## ADDENDUM

NO. 01

**PROJECT NAME:** 2024 Cy Ranch High School Additions And Renovations

**PROJECT NUMBER:** 01818-06-01

**1 AREA G1 - 1ST FLOOR PLAN**  
1/8" = 1'-0"

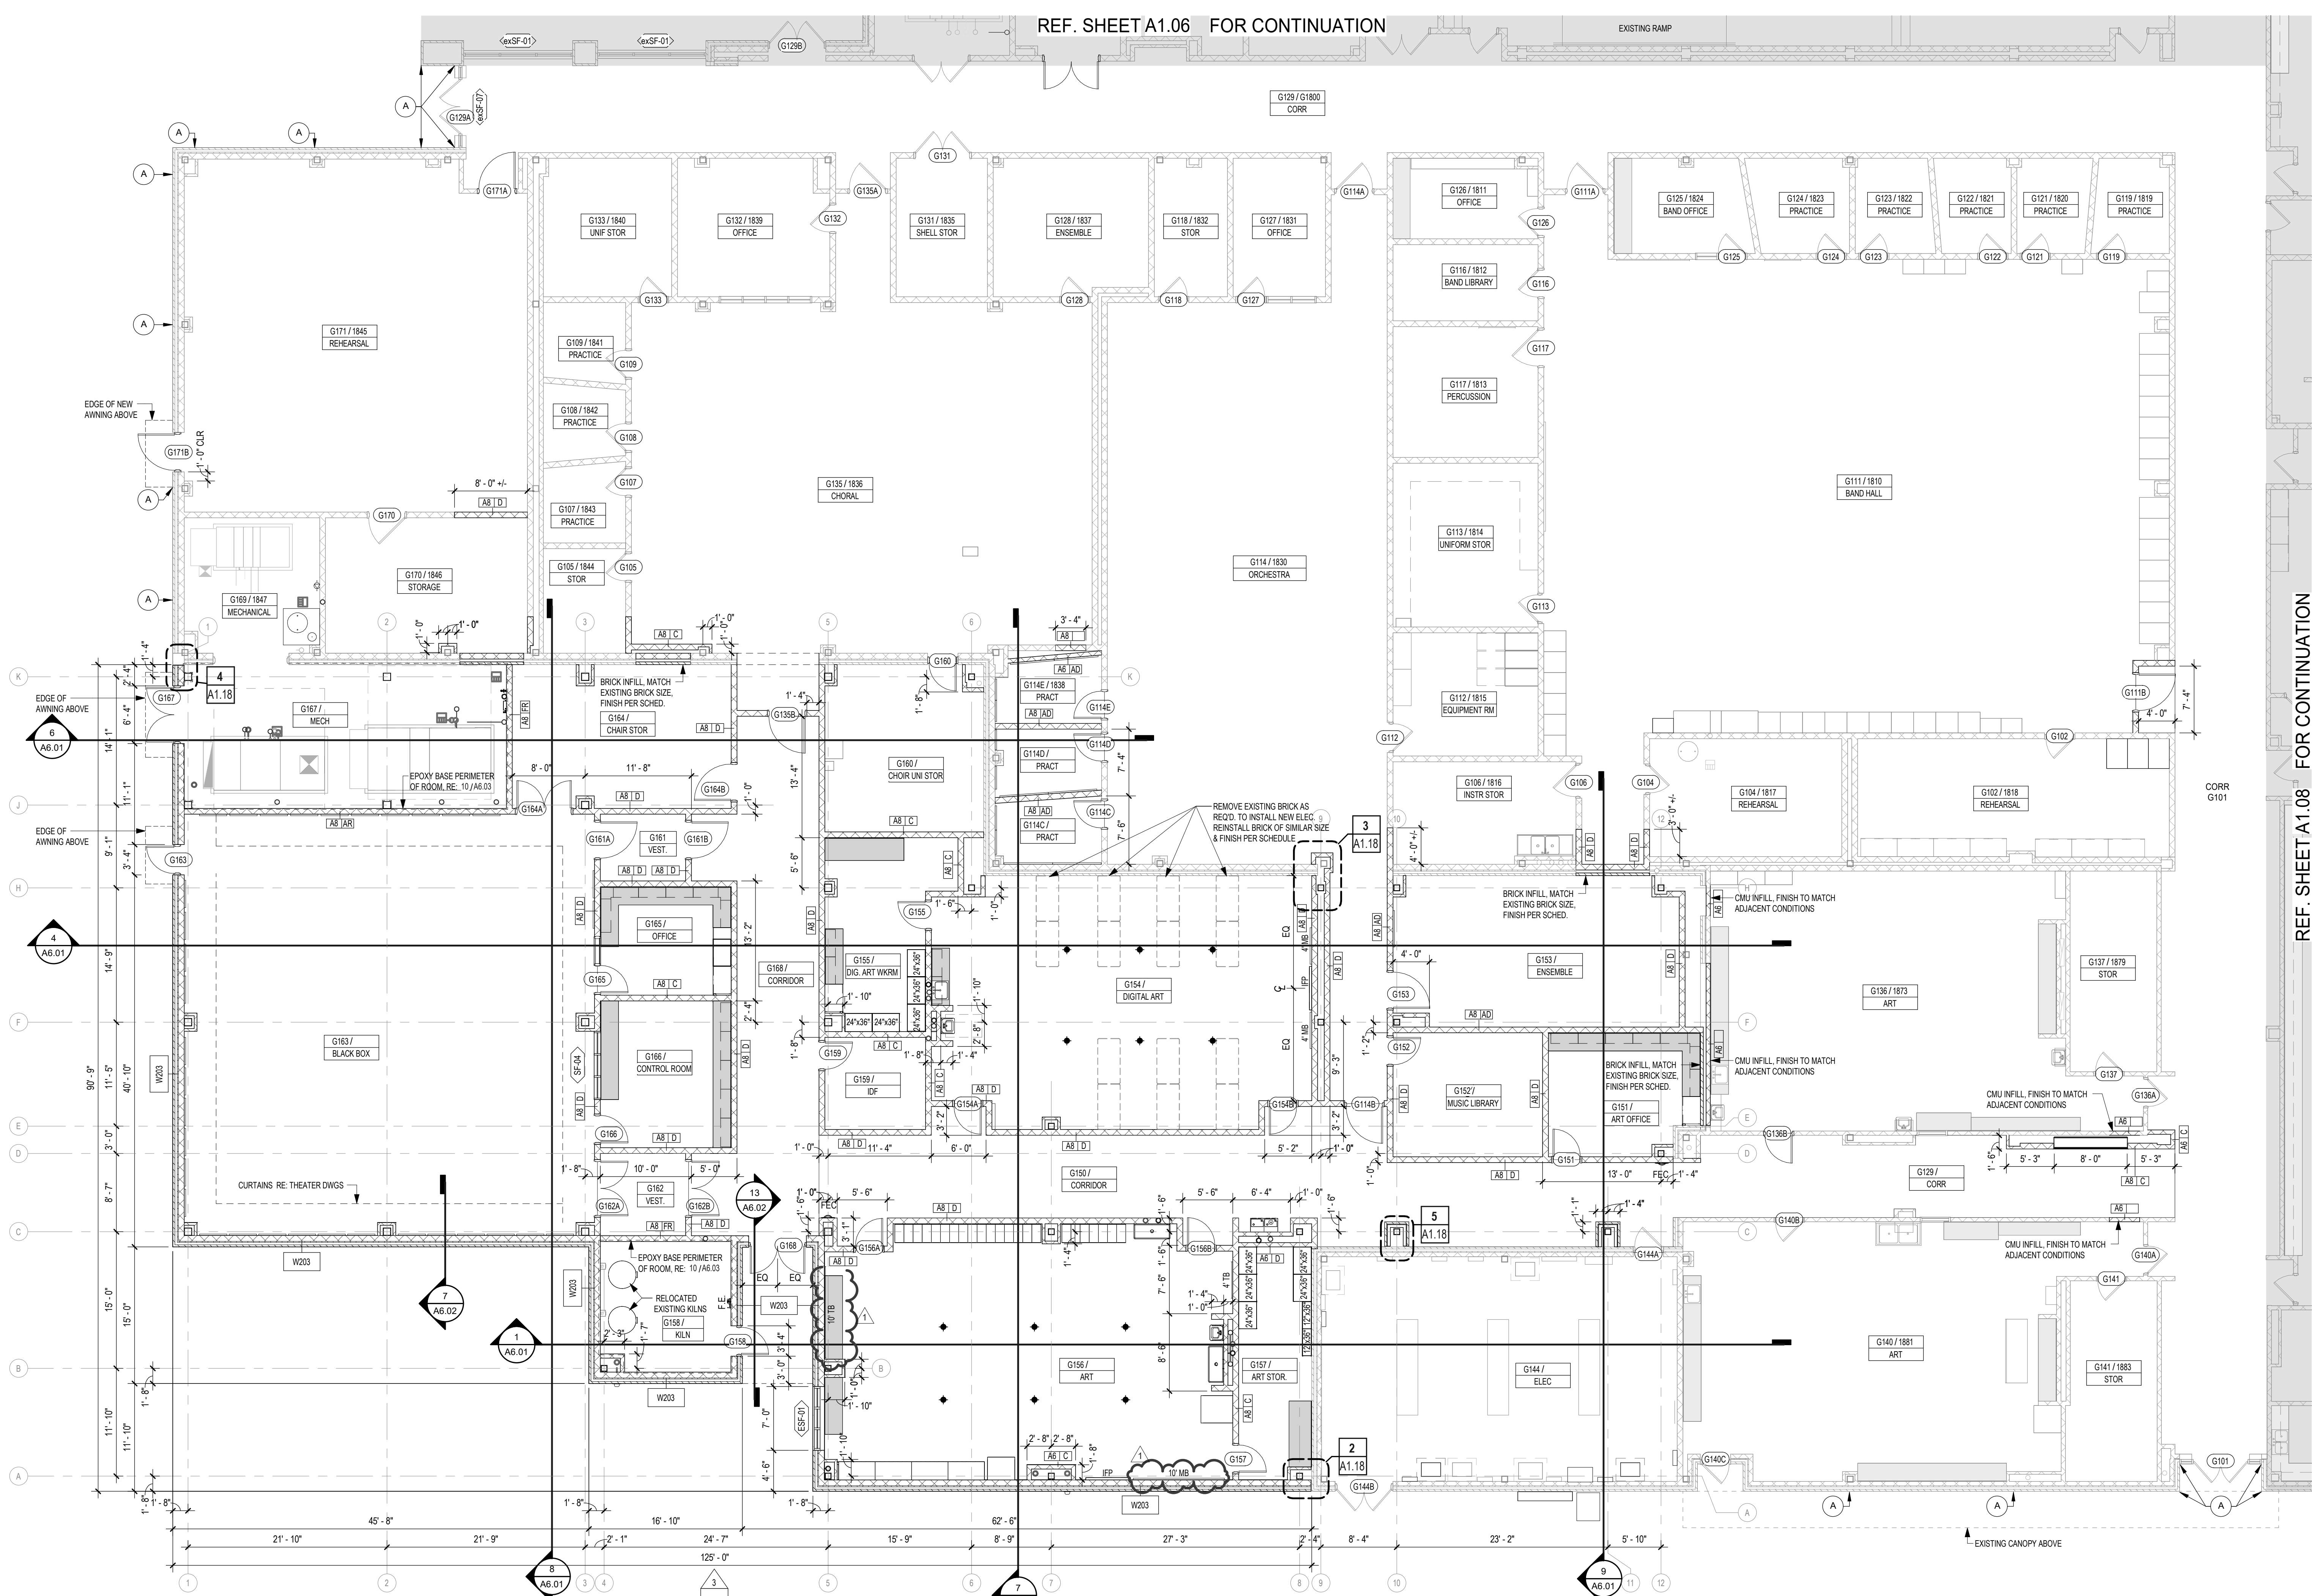
**AD No 1, Arch. Item 11: To the Drawings, Sheet A1.07, "AREA G1 – FIRST FLOOR PLAN"**

- 1) Revise size of tack board, marker board and size of casework in G156 Art per attached sheet

Job No. 01818-05-01  
Sheet No. A3.03  
Date: 11/11/2024

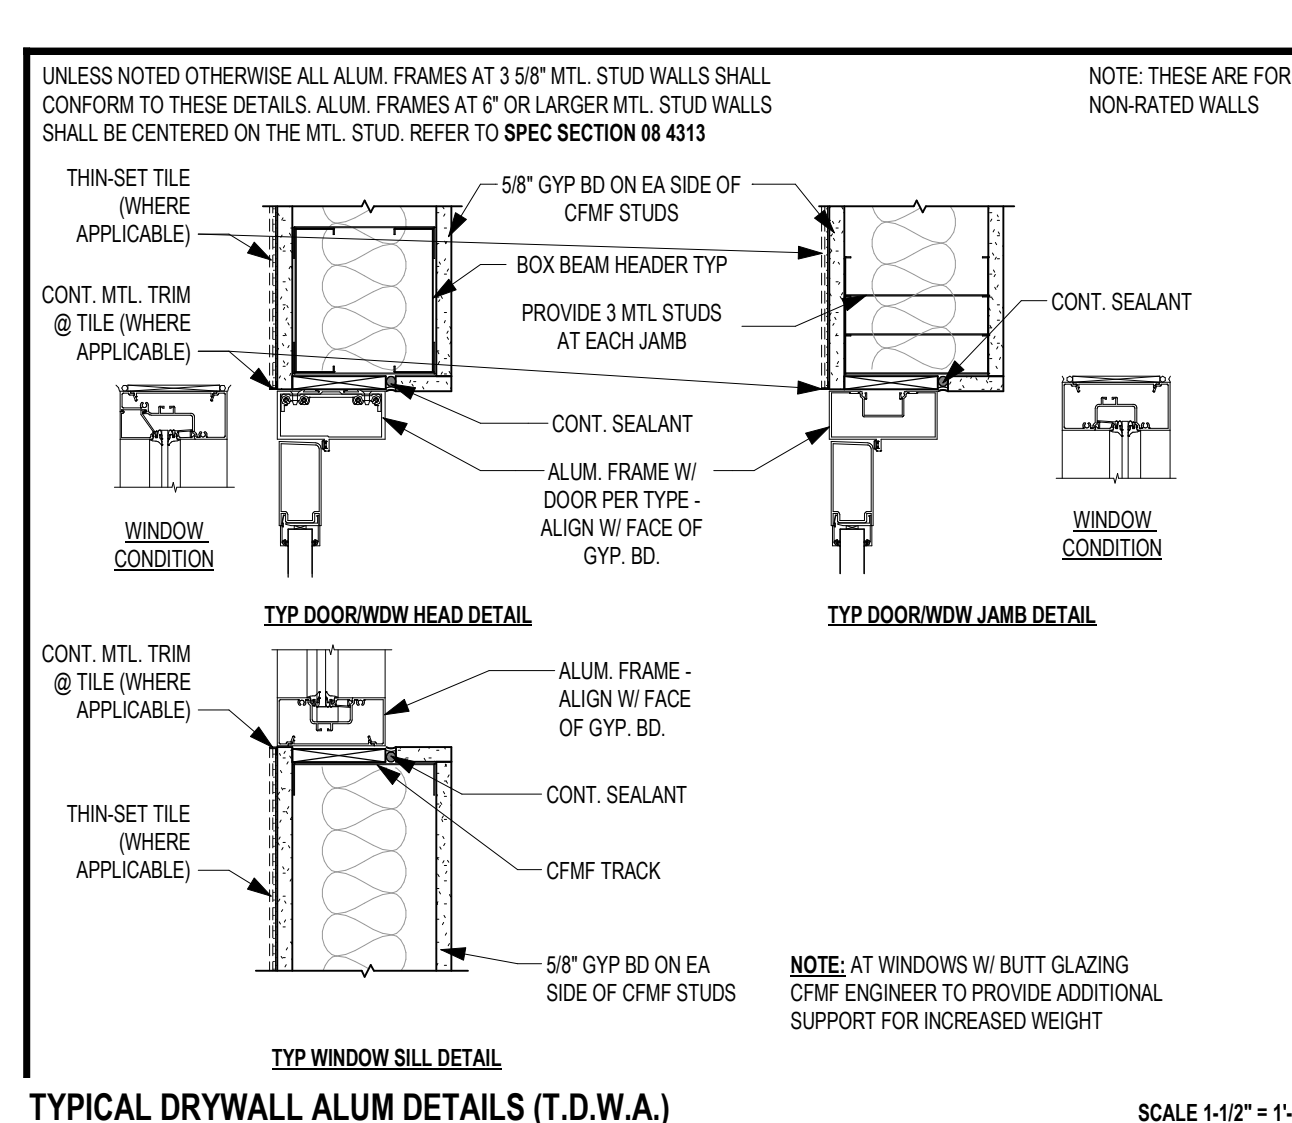
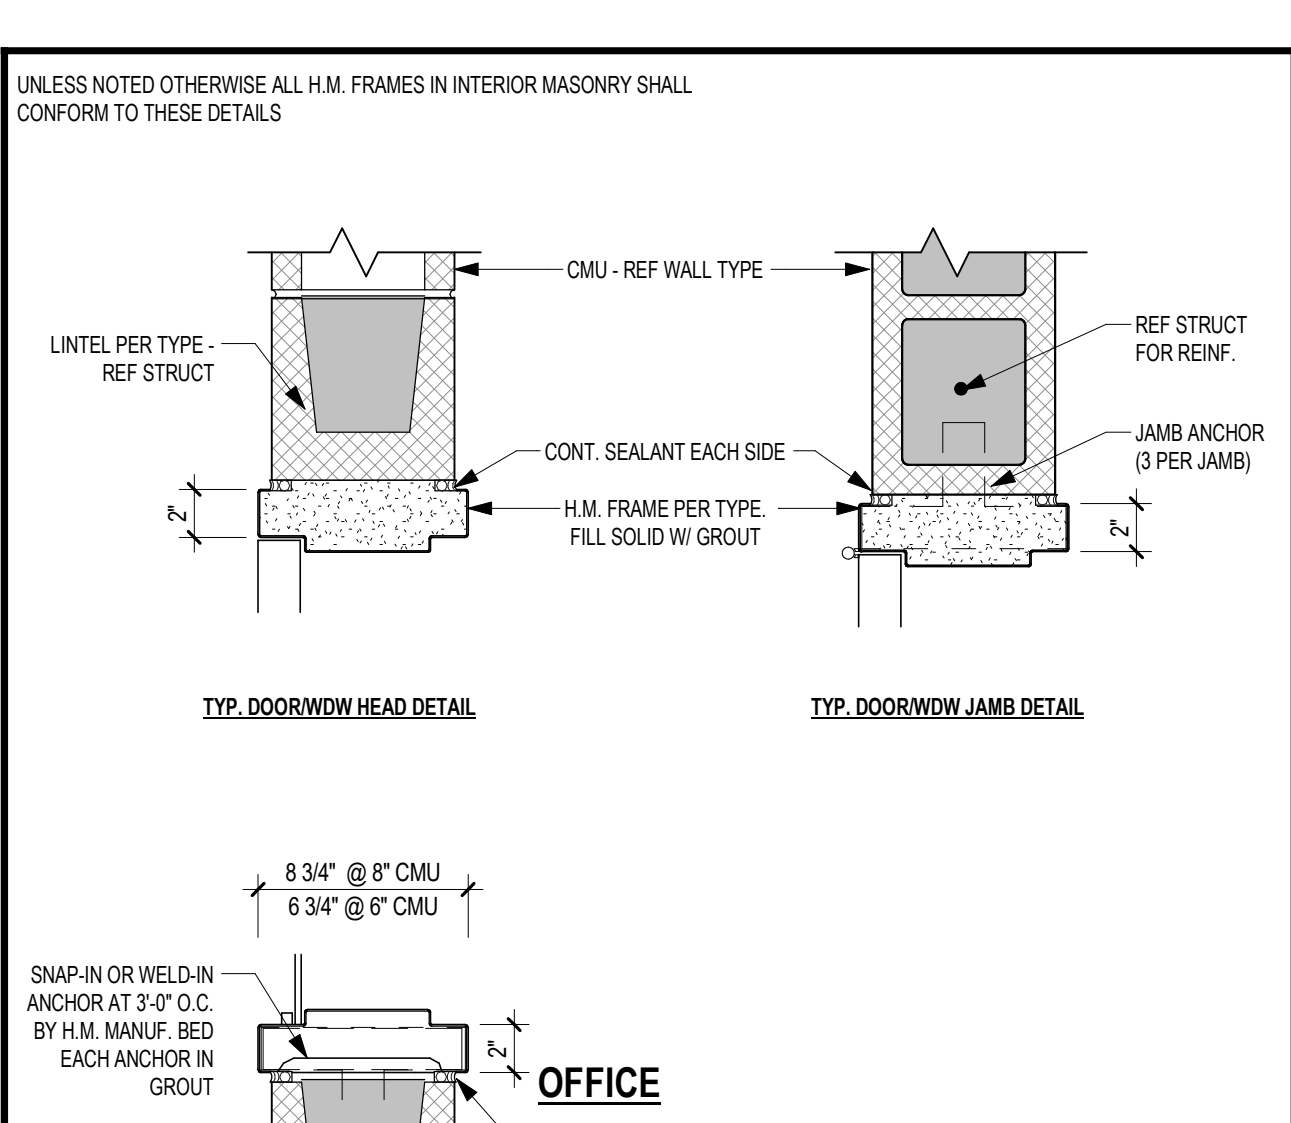
**AD No 1, Arch. Item 12: To the Drawings, Sheet A3.03, "STOREFRONT CONFIGURATIONS & DOOR AND WINDOW DETAILS"**

- 1) Revise details 2, 3, 19, and 20 per attached sheet
